SUBJECT: GRADED QUALITY ASSURANCE/PROBABILISTIC RISK ASSESSMENT IMPLEMENTATION PLAN FOR THE SOUTH TEXAS PROJECT ELECTRIC GENERATING STATION

This commission paper transmits the NRC staff's safety evaluation report (SER) regarding a proposed revision to the Operations Quality Assurance Program (OQAP) description applicable to the South Texas Project (STP) Electric Generating Station, Units 1 and 2. The proposal by the Houston Lighting and Power Company (the licensee), submitted on a voluntary basis, derives from the application of graded QA (GQA) controls, as permitted by NRC regulations (Title 10, Part 50, of the Code of Federal Regulations (10 CFR Part 50), Appendix A, General Design Criterion 1, and Appendix B, Criterion II), and is based on a risk-informed approach including Probabilistic Risk Analysis and traditional engineering evaluations. On the basis of the findings documented in the attached SER, the Office of Nuclear Reactor Regulation (NRR) intends to approve the licensee's proposed revision to the OQAP description for implementation at STP.

Figure 1

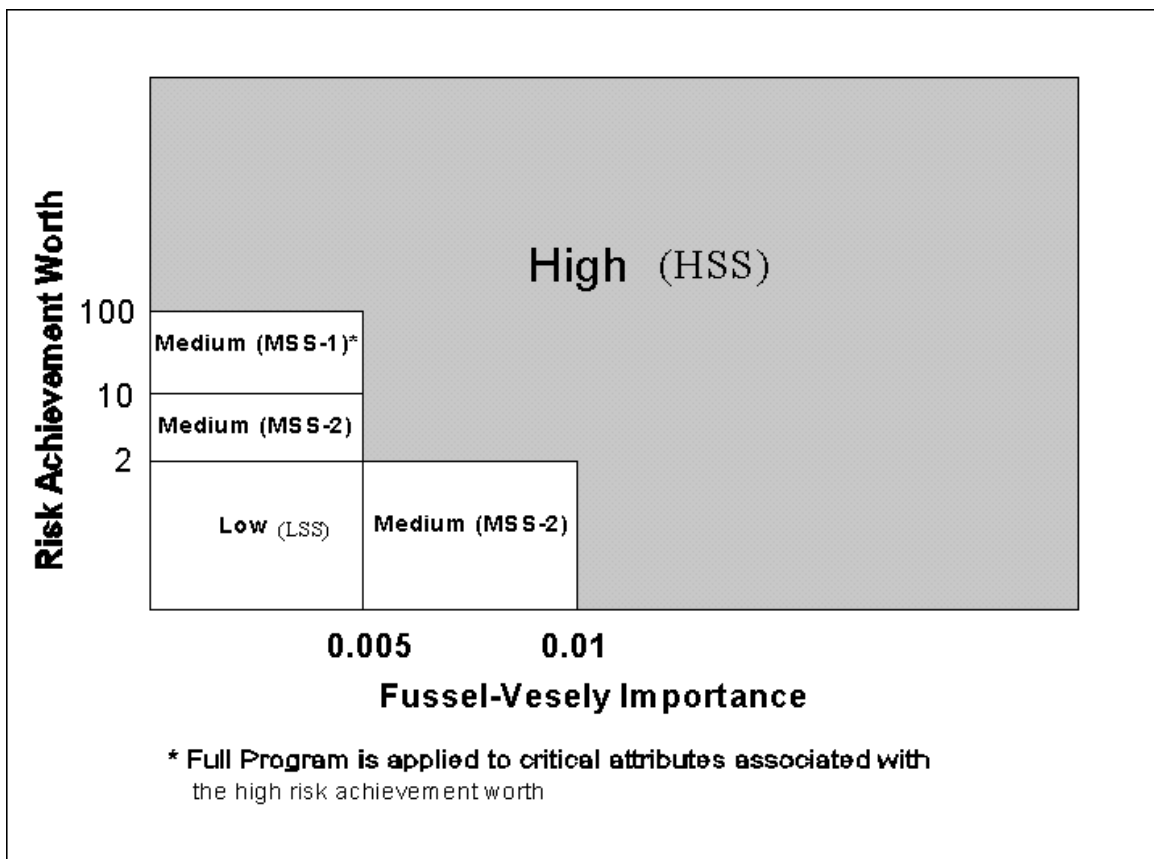
Figure 1 graphically illustrates the relationship between the RAW, FV, and the safety-significance categories for those SSCs modeled in the PRA. Since FV and RAW are relative measures, both CDF- and LERF-related results are compared to the guidelines and the SSC assigned the highest category. The staff finds this process acceptable, and that the suggested RAW and FV values provide reasonable assurance that plant equipment will receive a level of QA control commensurate with importance to safety. Furthermore, since the licensee assigns all SSCs with elevated RAW to the HSS or MSS-1 categories, the staff finds that the licensee's proposal conforms with the Draft RG DG-1064 (Reference 3) position that high reliability alone is not sufficient for reducing QA controls.

To investigate the contribution of plant safety attributable to the successful operation of the LSS SSCs, the licensee performed sensitivity studies in which the unavailability was simultaneously increased for all modeled SSCs which could be eventually subjected to reduced QA controls. The calculations for these studies were performed using the PRA logic model (rather than cut-set or sequence results), so truncation errors did not require special study. The staff finds the sensitivity studies to be an acceptable method of ensuring the potential aggregate risk impact of the reduction of QA controls on the LSS SSCs is well understood.
